### **CERTIFYING THE ENVIRONMENTAL IMPACT REPORT, ADOPTING THE FINDINGS OF FACT AND THE MITIGATION MONITORING PROGRAM FOR THE FREEPORT BOULEVARD BIKE LANES PROJECT (K15125100)**

# **PROPOSED FINAL EIR**

**EIR Text as Revised and Comments Received and  
Responses to Comments**

## **Freeport Boulevard Bike Lanes Project Draft**

**FREEPORT BOULEVARD BIKE LANES PROJECT**  
**PROPOSED PROJECT OPTION 1 - PARKING CONDITIONS**  
**5TH AVE TO 21ST ST**  
 Figure 4.3-8g

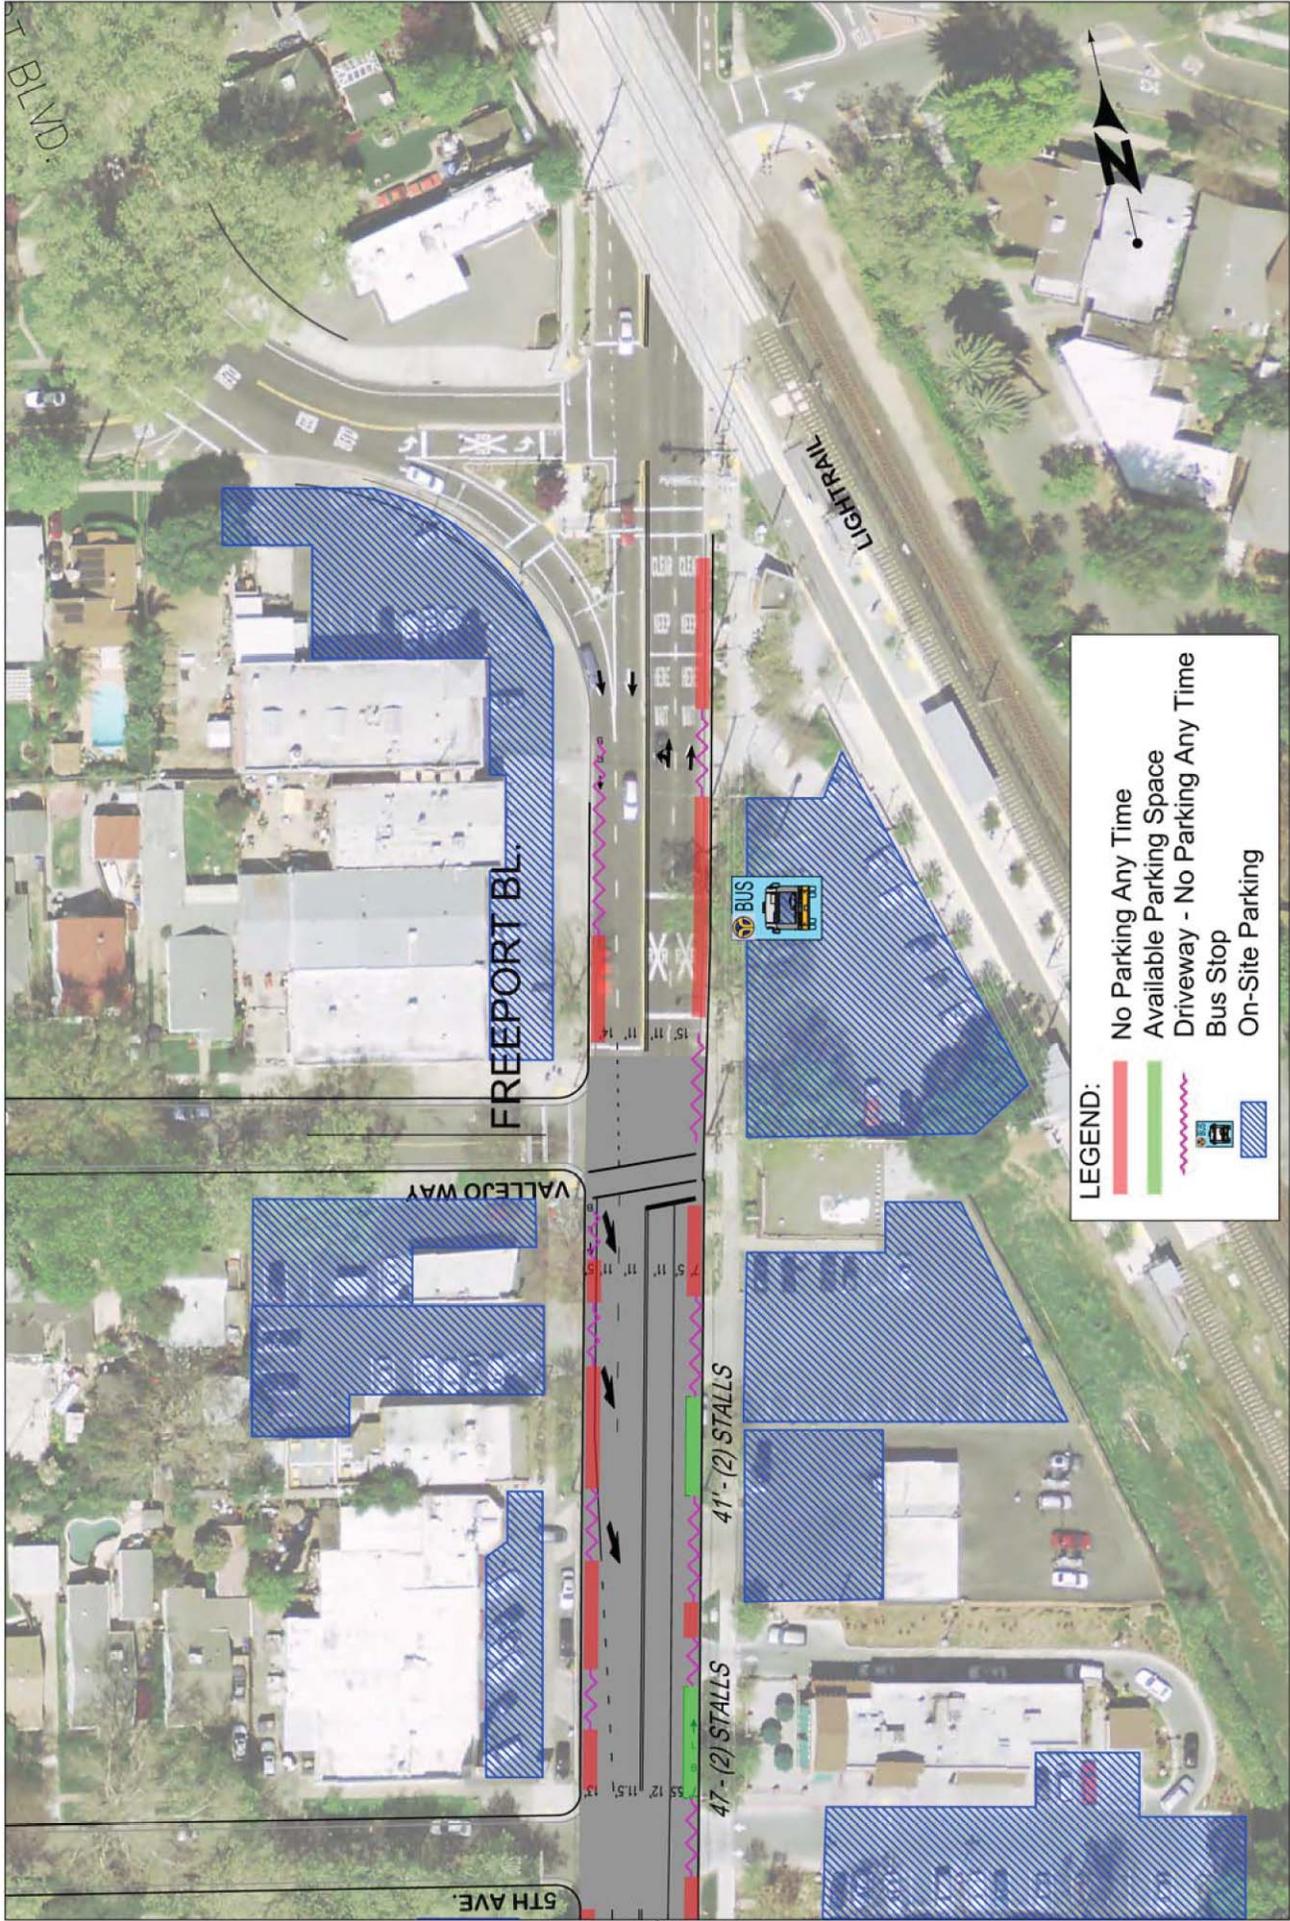
Replace page 4.3-23 with Figure 4.3-8G (at rear of this Chapter). Duplicates of Figure 4.3-8F were included in the DEIR and Figure 4.3-8G was inadvertently excluded. This was corrected in the website at the start of the public review period. This change should be reflected in the Final EIR.

Figure 4.3-8g should be inserted on page 4.3-23.

Figure 5.4-5

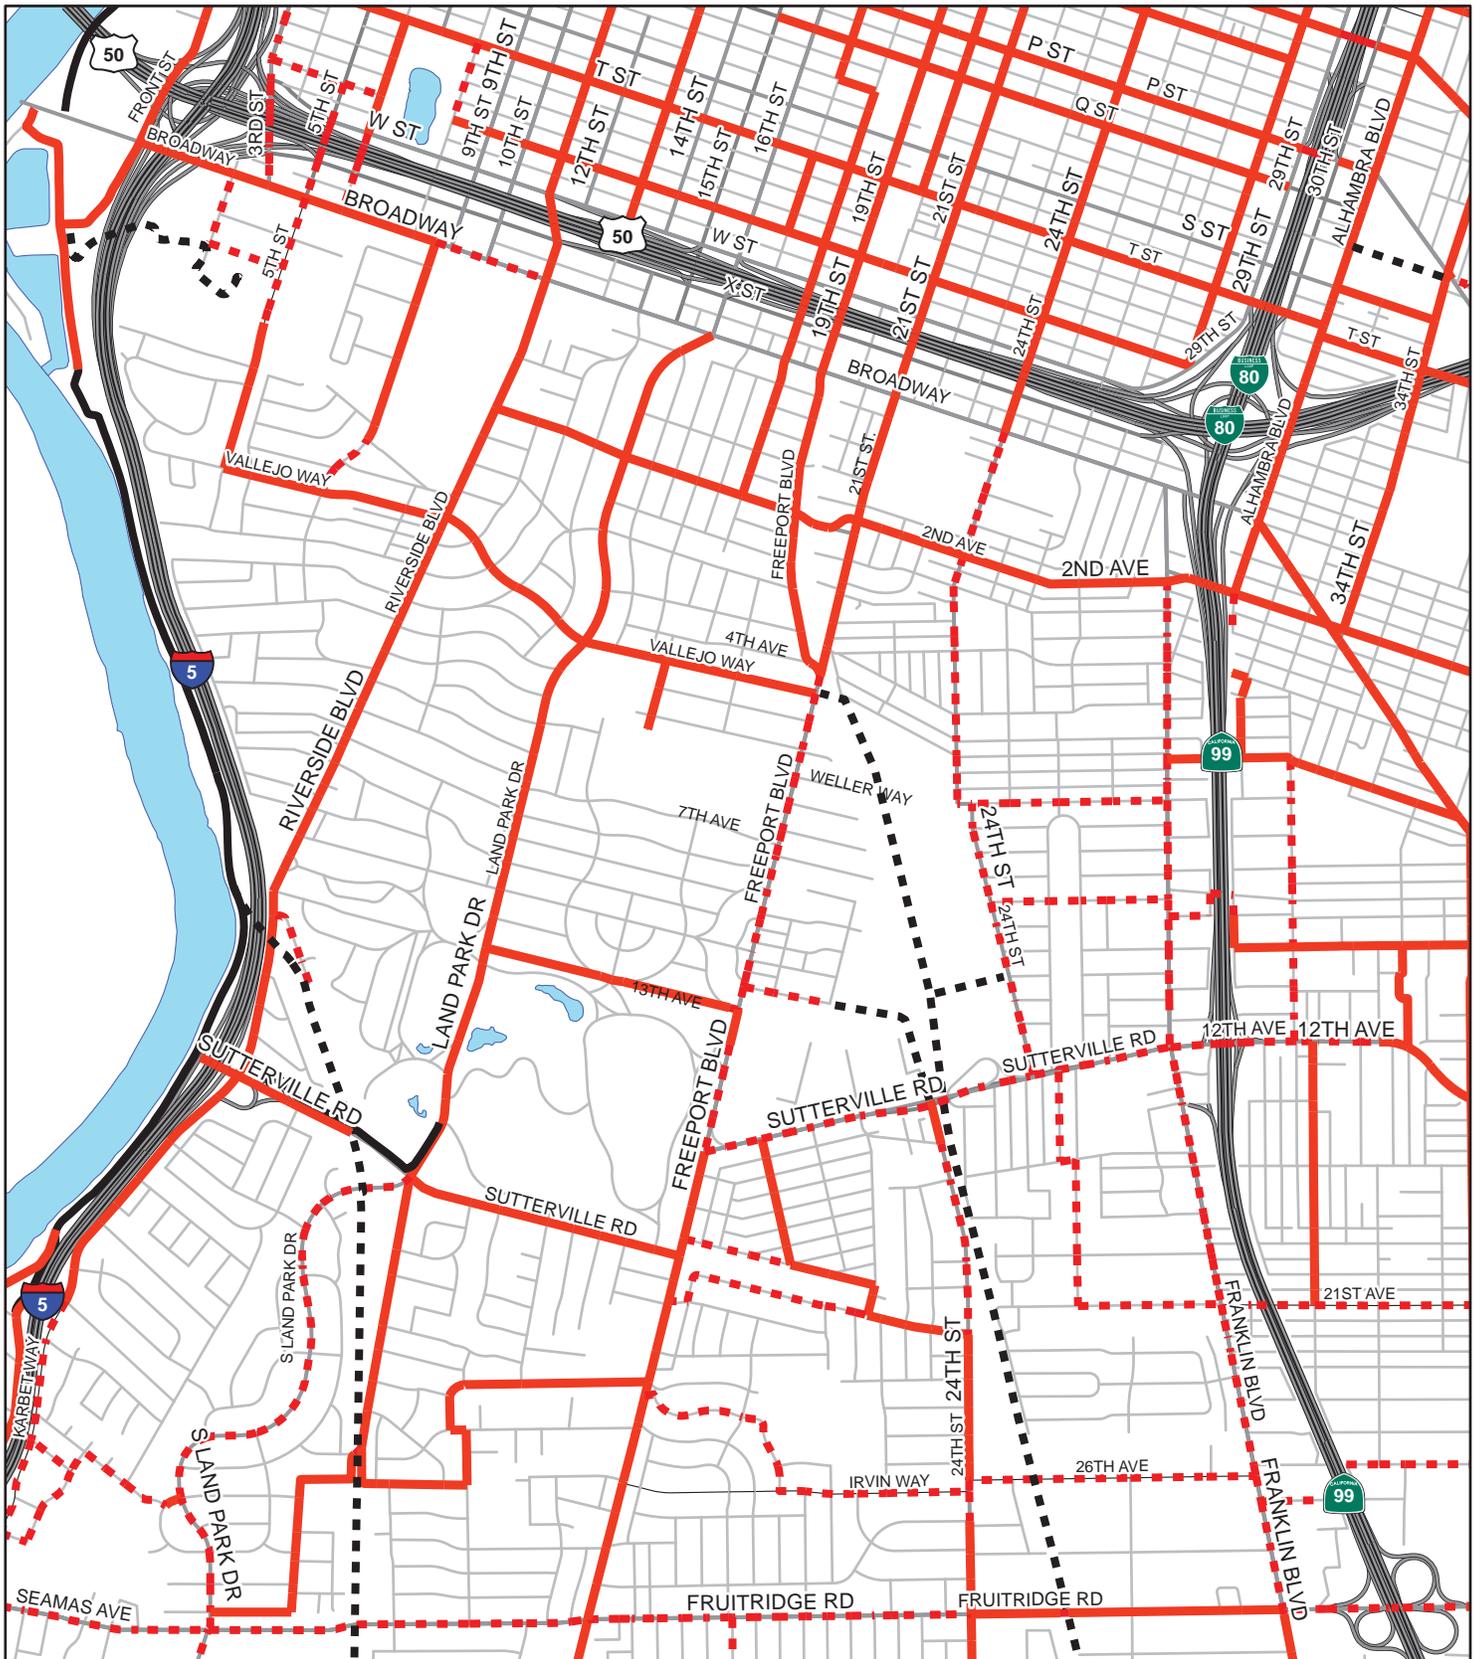
Page 5.4-13, Figure 5.4-5.

Figure 5.4-5 included in the Draft EIR has an incorrect legend denoting Class II bikeways. A corrected figure which describes these bikeways as “on-street” bikeways has been provided at the end of this Chapter.

Figure 5.4-5 as corrected should be inserted on page 5.3-13.
